CERTIFICATE OF COMPLETION/OPERATION PERMIT

Address of Property 9036 Browne Rd

SOIL/SITE EVALUATION
for ON-SITE WASTEWATER SYSTEM

PROPOSED PLOT PLAN

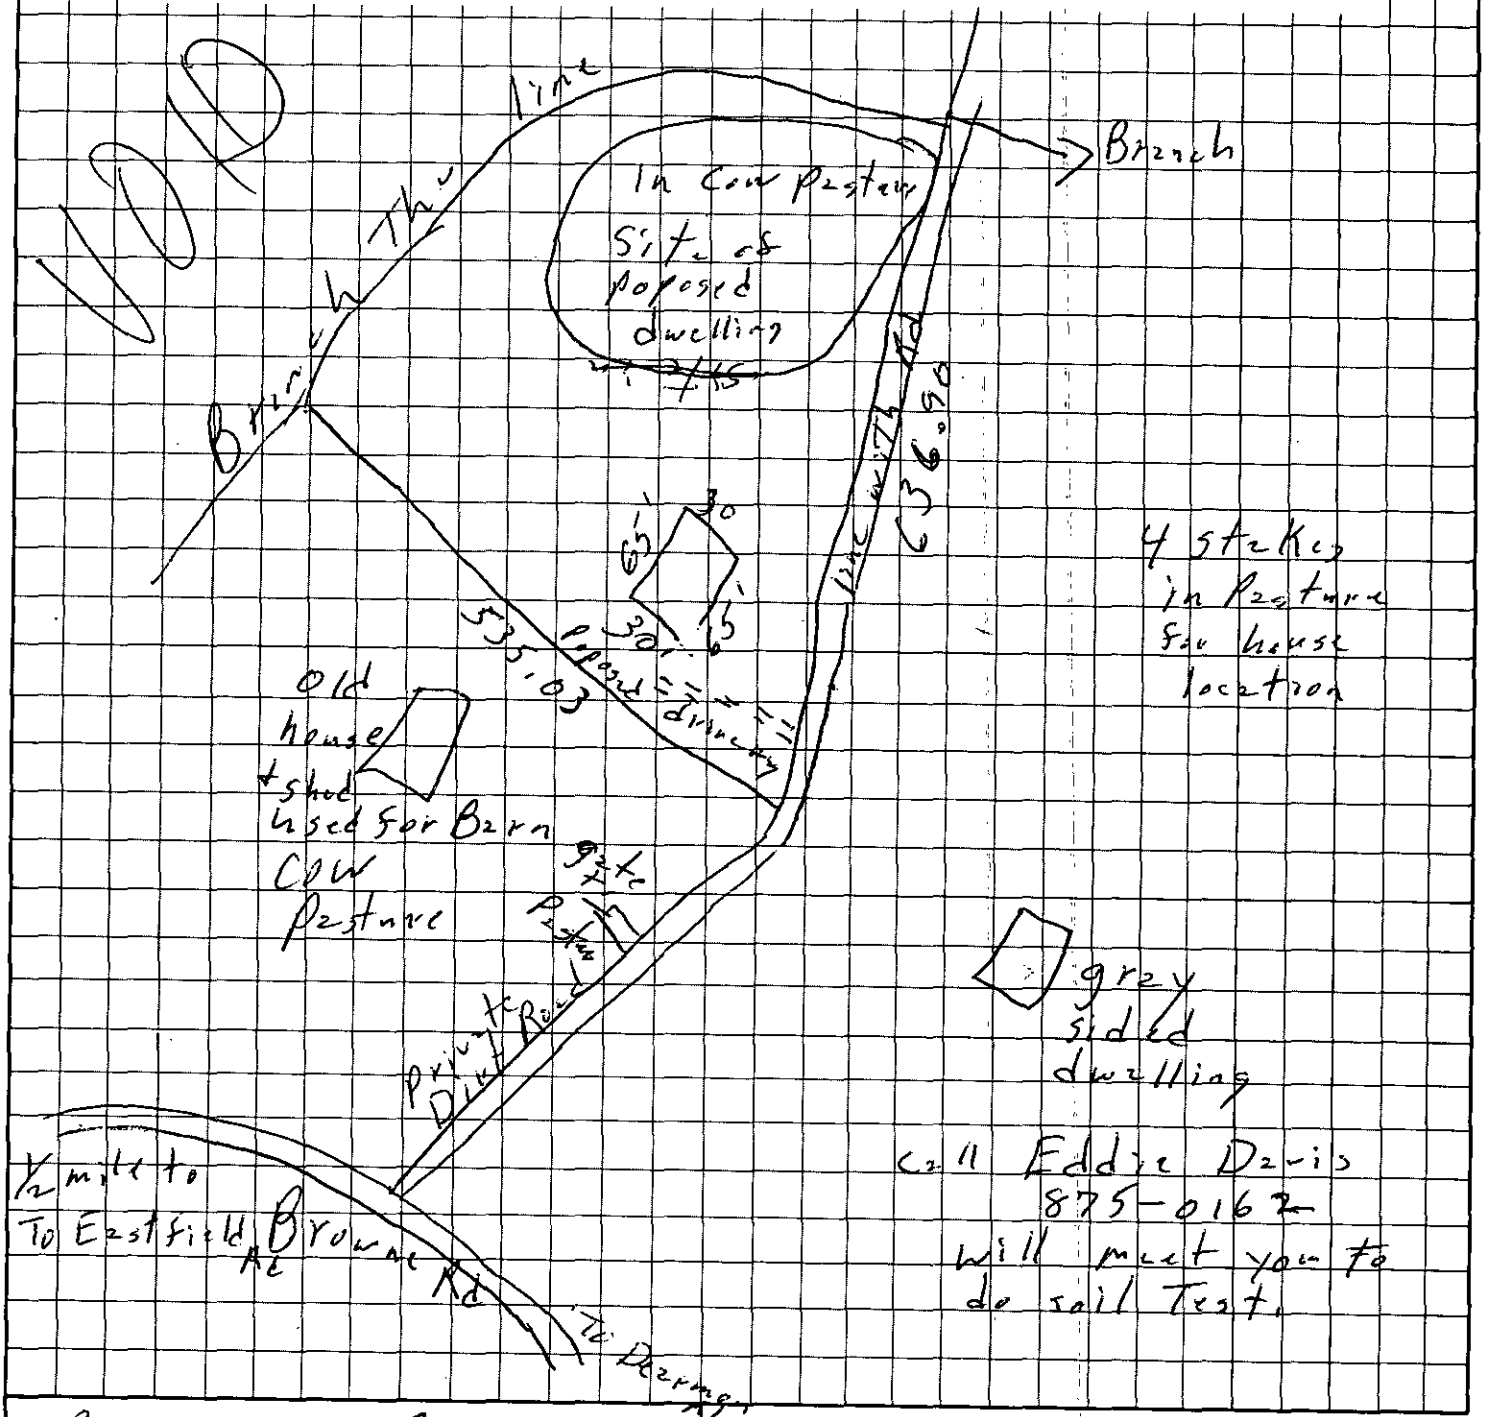
3 Bedroom Residence
1500 sf
5 lines x 80' long x 3' wd x 12" stone
400 TUF
Type II Repair Area
CMUD water
Keep lines on contour of land
40' from ~~front~~ property line to front left corner of house
117' from front property line to front left house corner
